TECHNICAL SERVICE BULLETIN

NO. 73-A-8

Austin MG

FUEL TANK SLOW FILLING

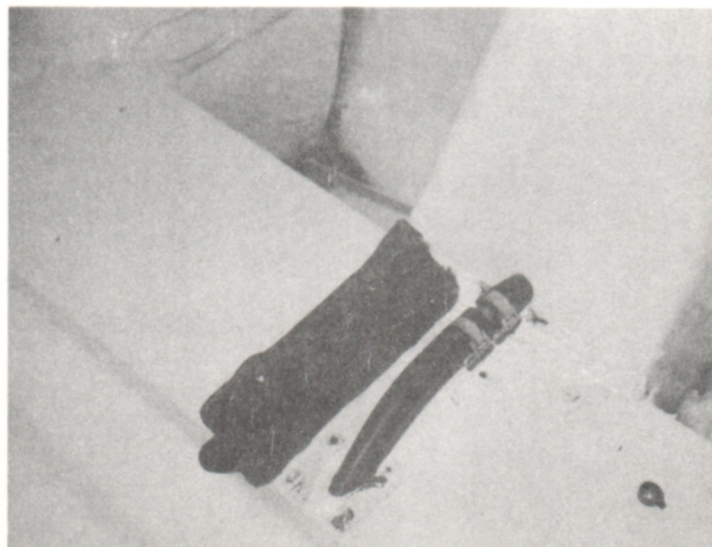
If this condition is encountered, it may be caused by a partially trapped or kinked breather tube.

This can be rectified by removing the trunk mat and removing the four screws securing the protector plate (see photograph) which will expose the breather tube. Check that the tube is free of kinks and that it has not been trapped by the protector plate.

NOTE: It may be necessary to shorten the length of the venting tube to insure a bend-free routing of the tube.
